Review Statement and Evaluation of the Swedish Nuclear Fuel and Waste Management Co's (SKB) RD&D Programme **2007**

Swedish Nuclear Power Inspectorate (SKI)

Our reference
SKI 2007/1218

SKI's Review Statement on the Swedish Nuclear Fuel and Waste Management Co's (SKB) RD&D Programme 2007

Figure 2. Presentation of overall planning in RD&D Programme 2004

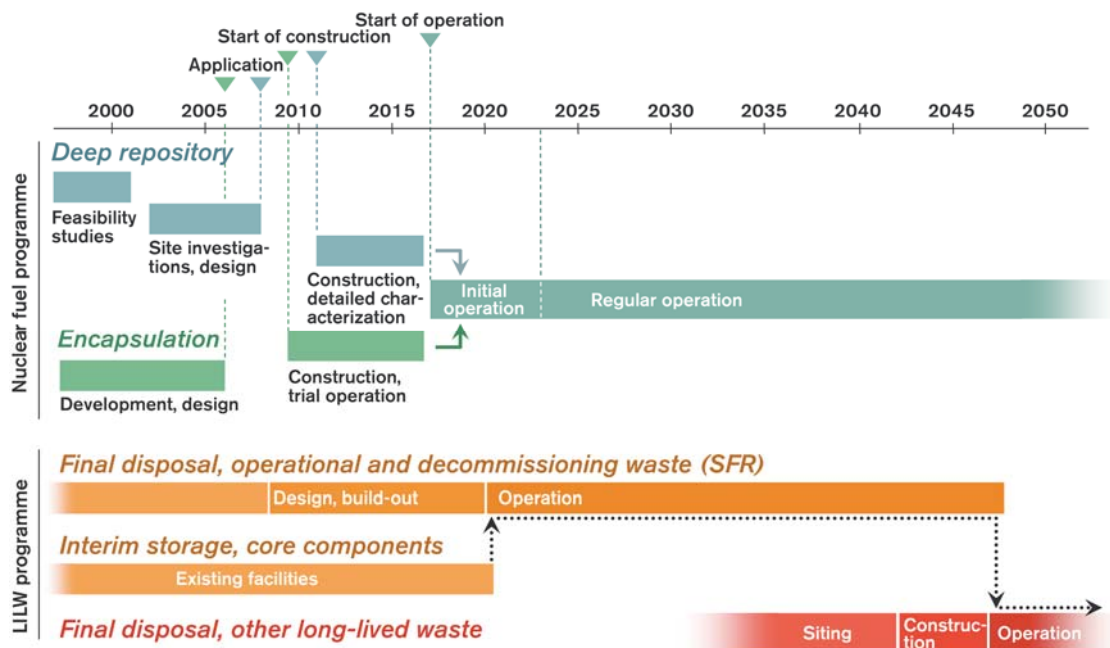
The figure below from RD&D Programme 2004 (Figure 2) clearly shows that detailed investigations will take place during the construction stage. In the corresponding report in RD&D Programme 2007 (cf Figure 1 above), corresponding information on detailed investigations is lacking. SKI experiences that the concept of detailed investigations has been generally toned down in RD&D Programme 2007.
